Private Fuel Storage, L.L.C.

January 25, 2001

RISK ASSESSMENT OF ACCIDENTS INVOLVING CRUISE MISSILES
DOCKET NO. 72-22/TAC NO. L22462
PRIVATE FUEL STORAGE FACILITY
PRIVATE FUEL STORAGE L.L.C.

RISK ASSESSMENT
OF
CRUISE MISSILE ACCIDENTS
IMPACTING
PRIVATE FUEL STORAGE LLC
INDEPENDENT SPENT FUEL
STORAGE INSTALLATION

Figure 7: High Enroute Chart Showing Restricted Airspace

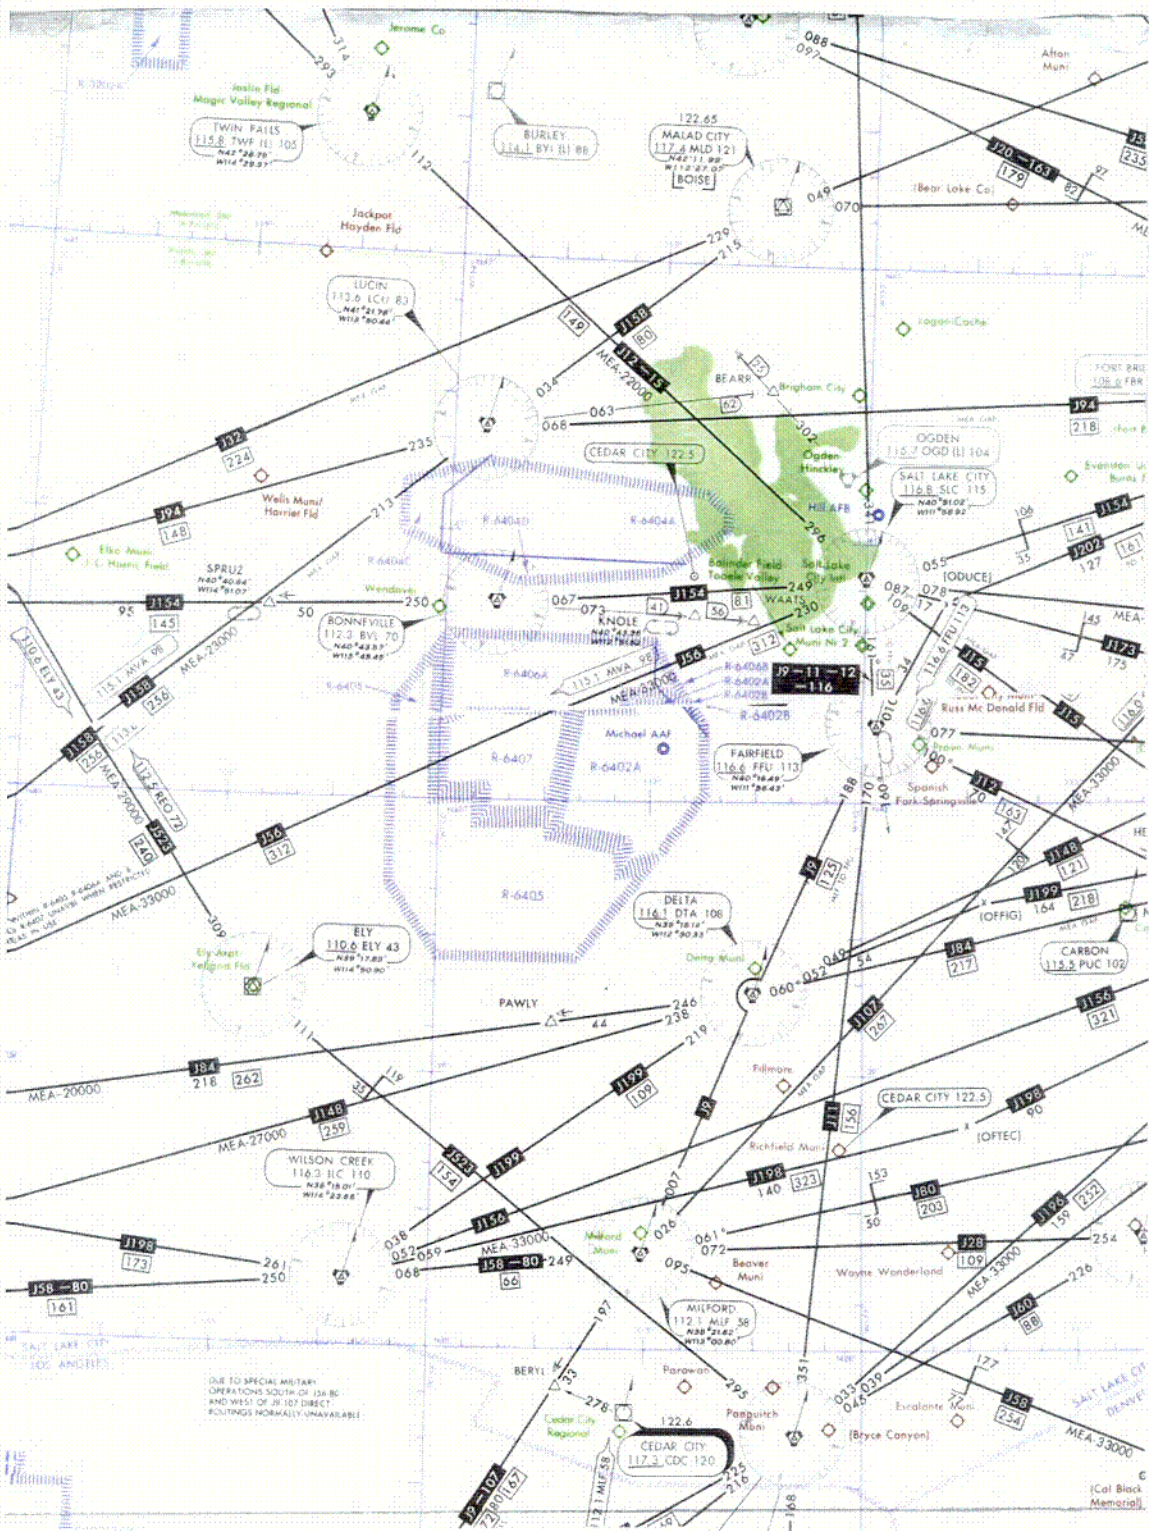
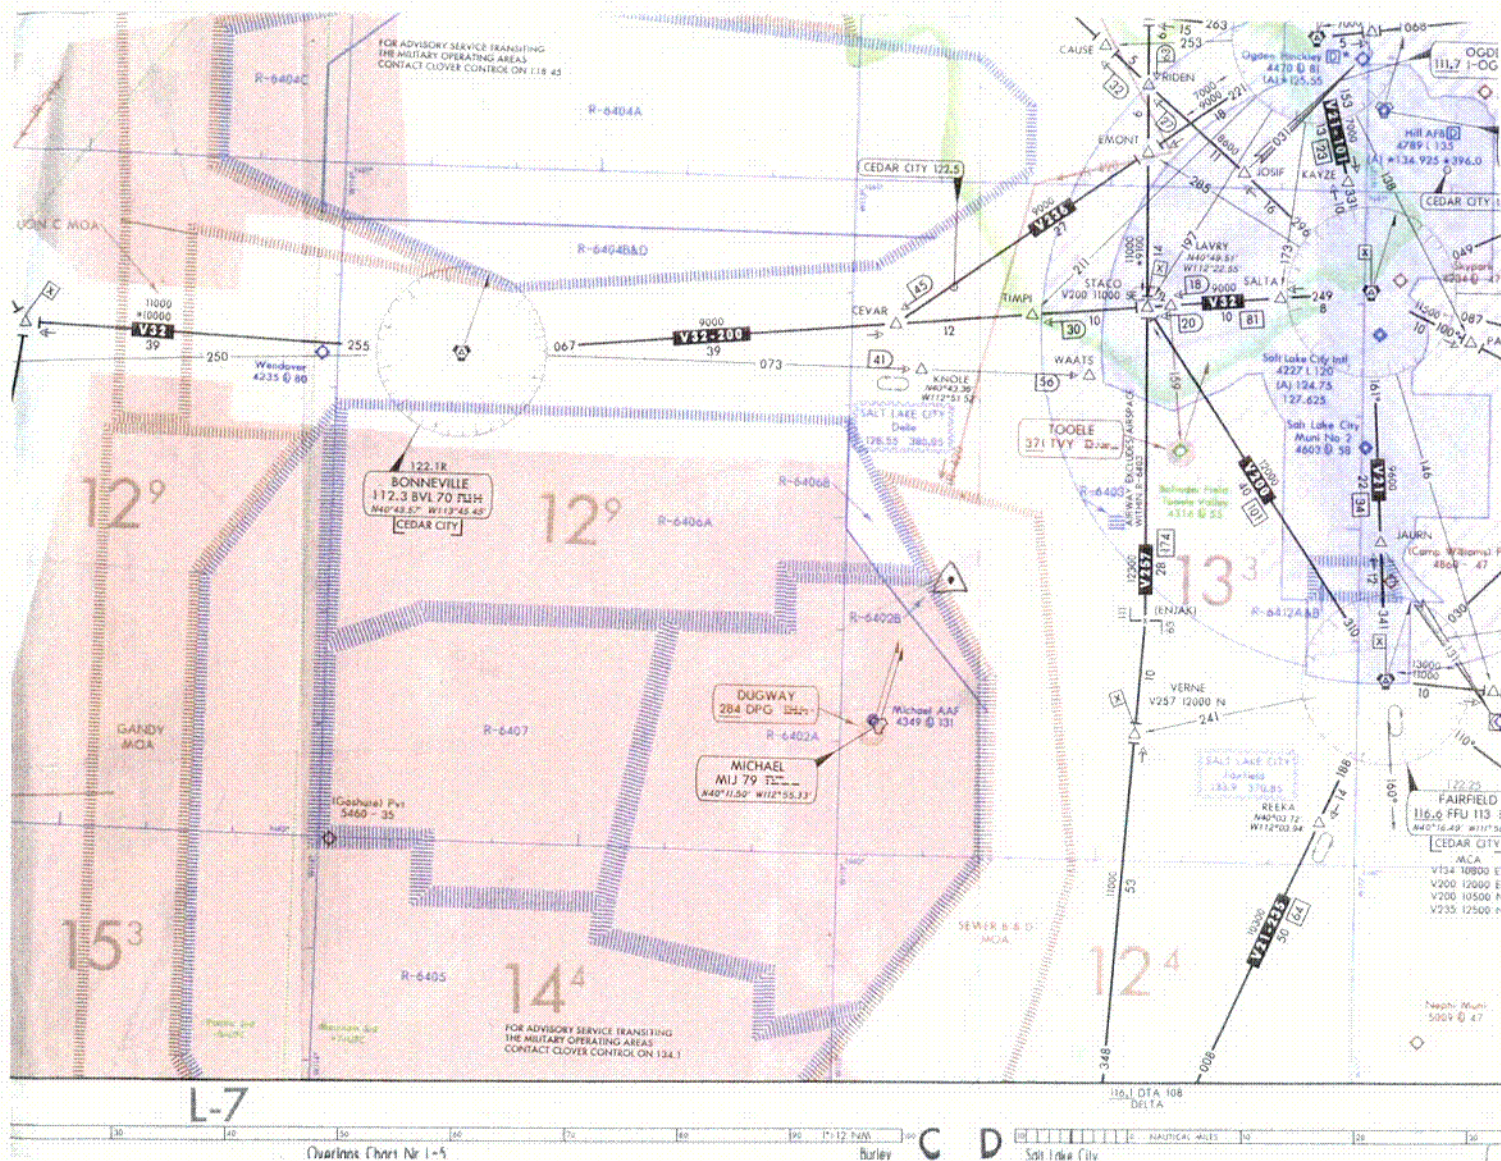
Figures 7, 8 and 9 to the Report (Revision 0) are difficult to read.

The color prints probably lost quality in the copying process and we are providing original color prints of these Figures to both the Staff and the Center.

Figure 9: Military Low-Level Route Structure Associated with UTTR

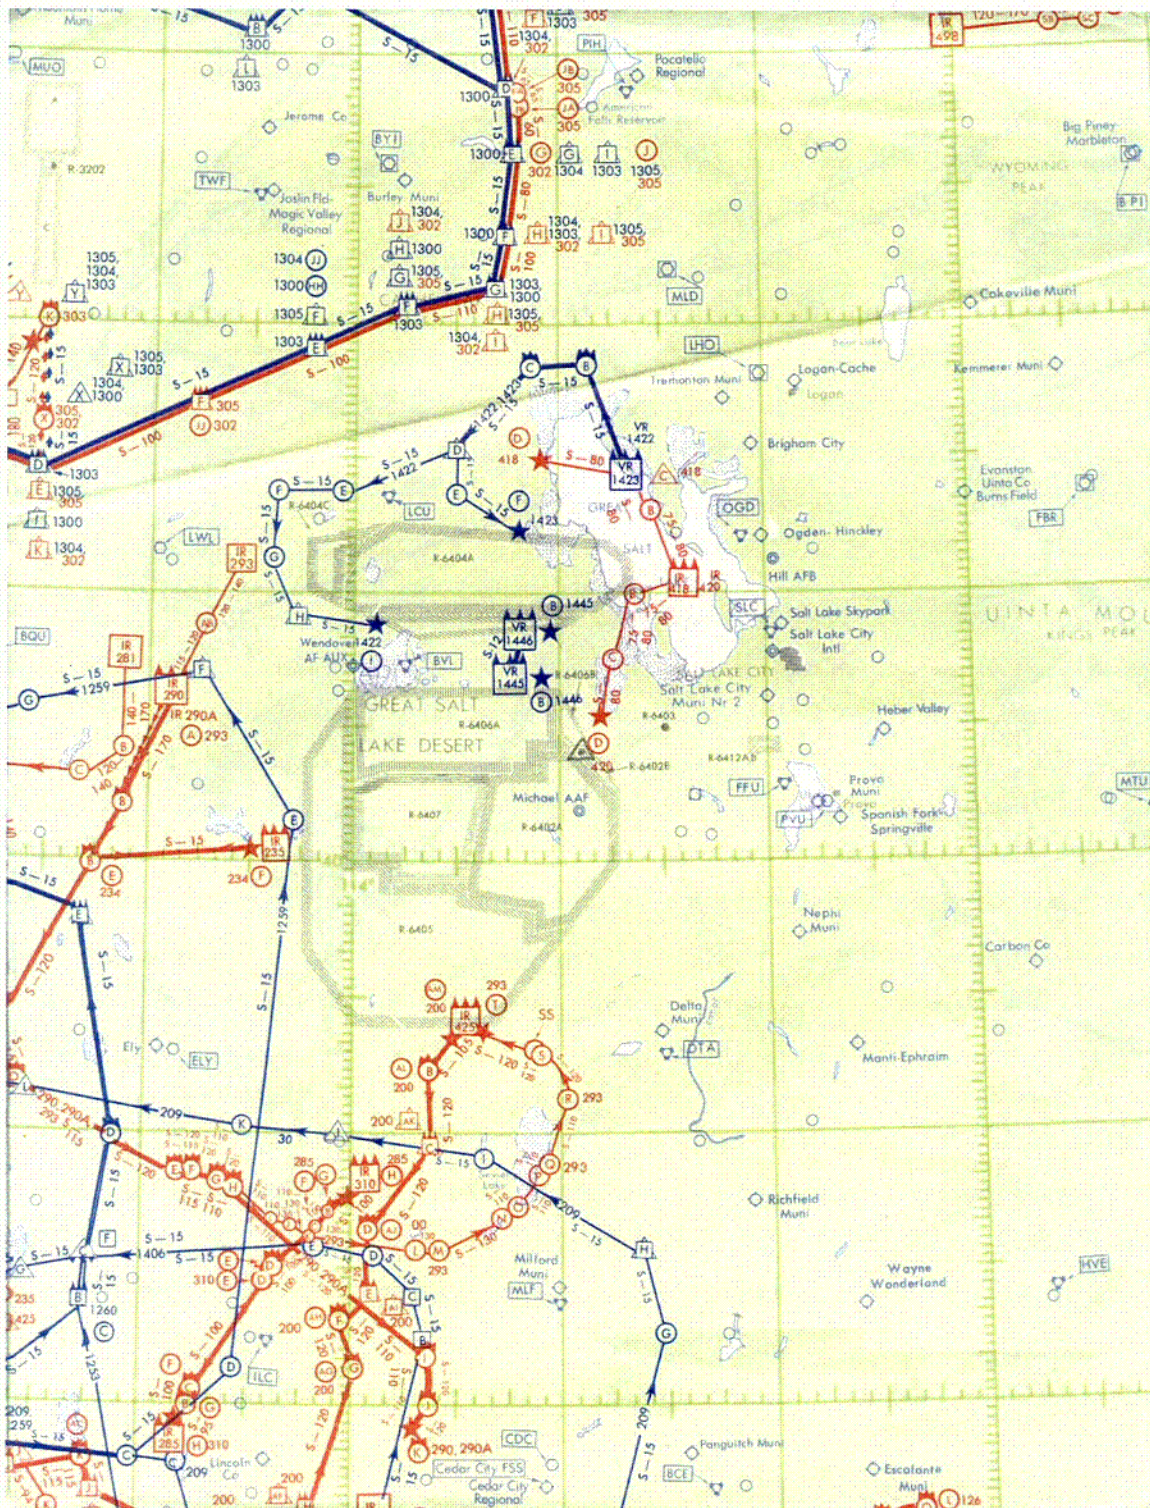
Figure 9 in the Report (Revision 0) is described as "the military low-level route structure associated with UTTR" on page 12, but on page 15 it is labeled as "FLIP Military Route Planning Chart." Are both of these correct?

Both are correct; FLIP is an acronym for Department of Defense "Flight Information Publication." The title to Figure 9 in the enclosed Report (p. 15) has been revised to clarify that it reflects the "Military Low-Level Route Structure Associated with UTTR."

Figure 15: South Range Cruise Missile Routing

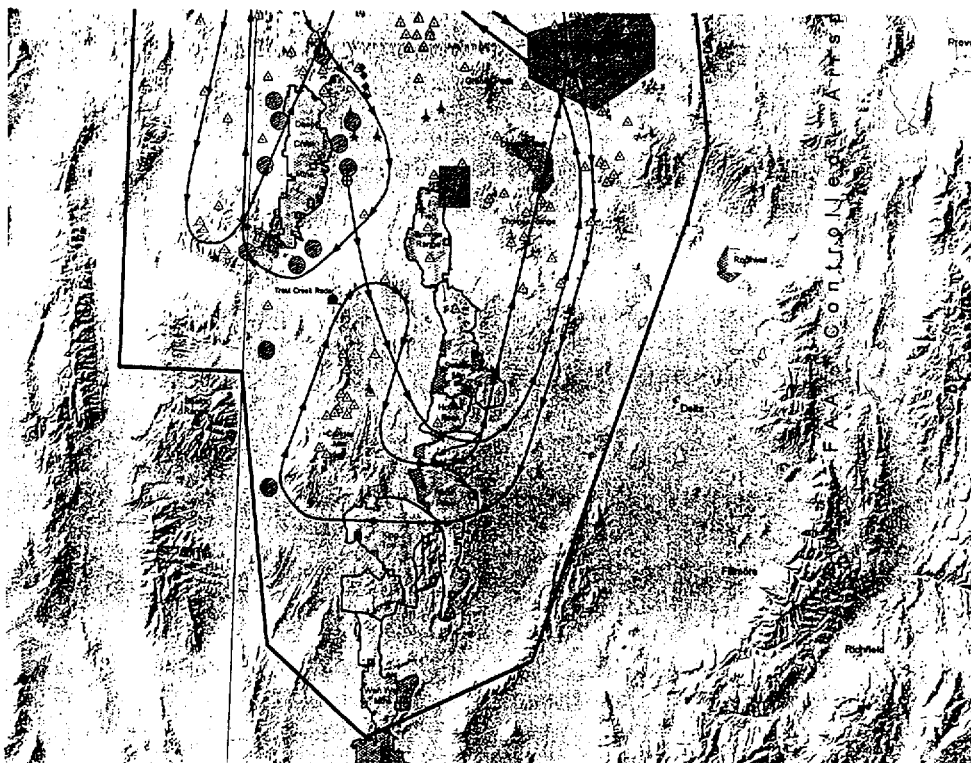
On page 36 of the Report (Revision 0), it says that "Cruise missile trajectories are tangential (as opposed to radial) to the PFSF, with a point of approach no closer than 10 nm [nautical miles] from the facility," but Figure 15 on page 27 shows a route that is radial to the PFSF at various points. How do you reconcile those two things?

This sentence in the enclosed Report (p. 36) has been revised to clarify that "[a]t their closest point of approach to the PFSF, cruise missile flight trajectories are tangential (as opposed to radial) to the PFSF, coming no closer than 10 nm [nautical miles] from the facility." The points on the route shown in Figure 15 at which the trajectory is radial to the PFSF are to the south and west of Michael Army Airfield, more than 15 nautical miles from the PFSF and well beyond the downrange distance that a cruise missile would travel upon activation of the FTS system.

Figure 16A: Downrange Distance Graph After FTS Termination
(From Boeing Tech Order Data)

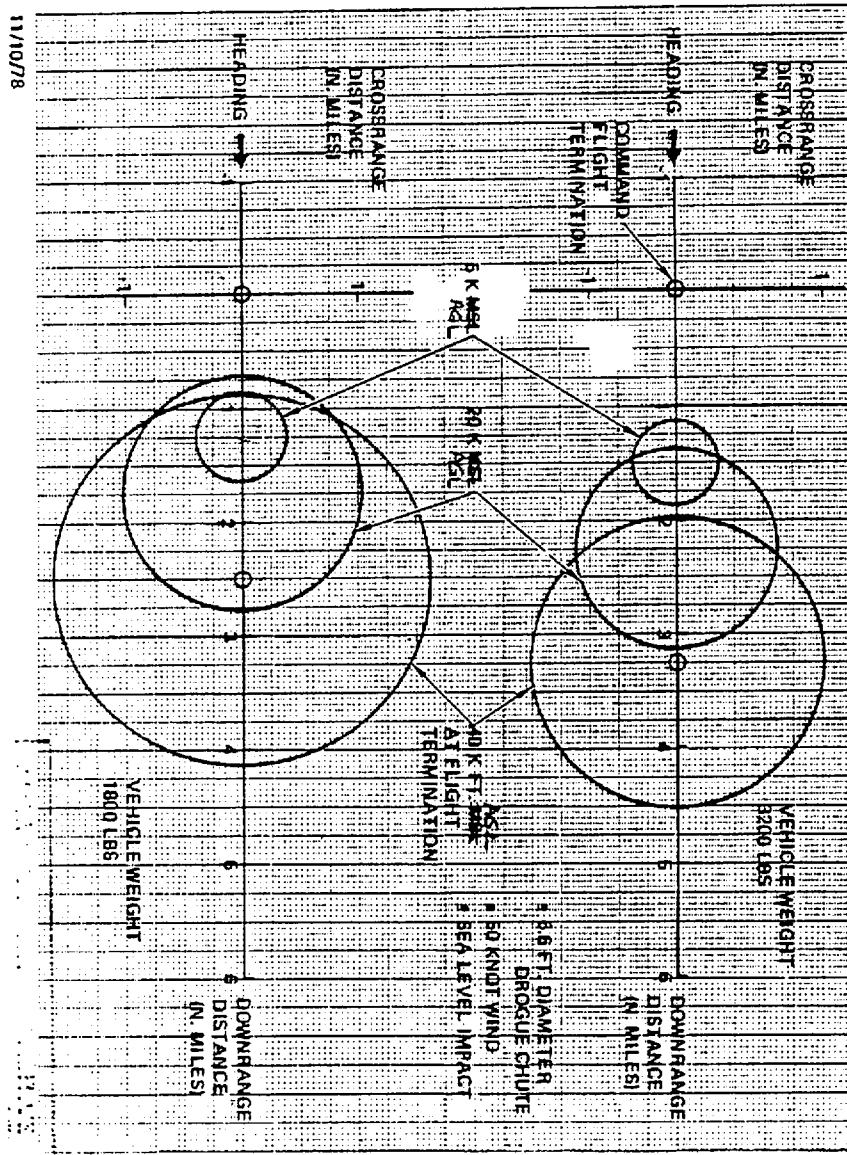
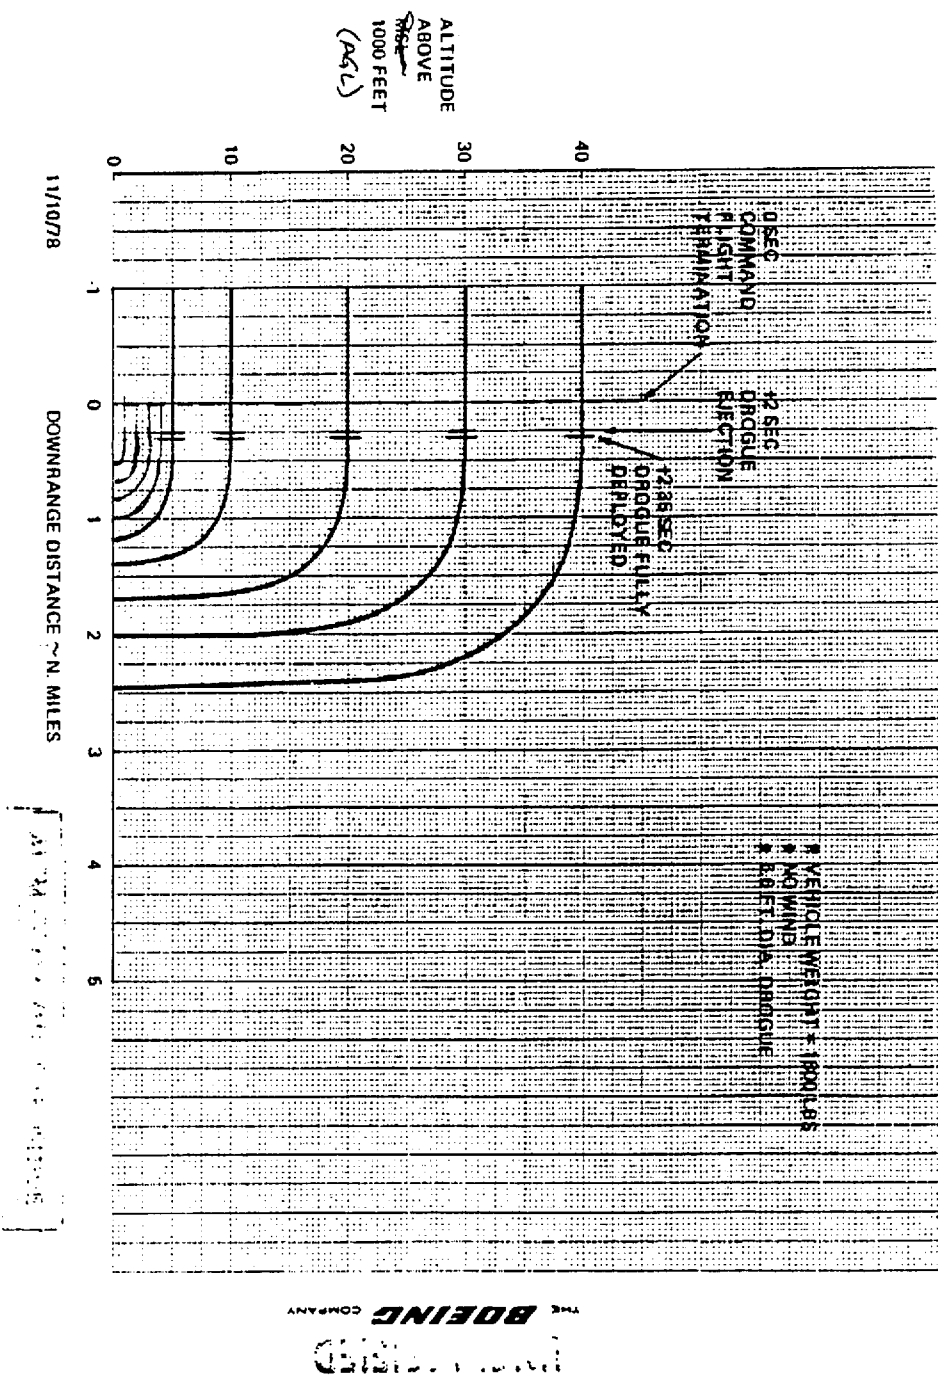
A 50-knot wind is assumed in Figure 16A of Revision 0 of the Report (p. 33). Is a wind assumed in Figure 16B? The figure itself says it does not assume a wind.

The enclosed Report (p. 33) has been revised to clarify that only the distances in Figure 16 A (which depict the impact footprints for the two extremes of vehicle weight, launch weight and empty weight) conservatively assume a 50-knot wind blowing in the most disadvantageous direction. Figure 16 B (which only depicts trajectory profile and not impact footprints) does not include wind.
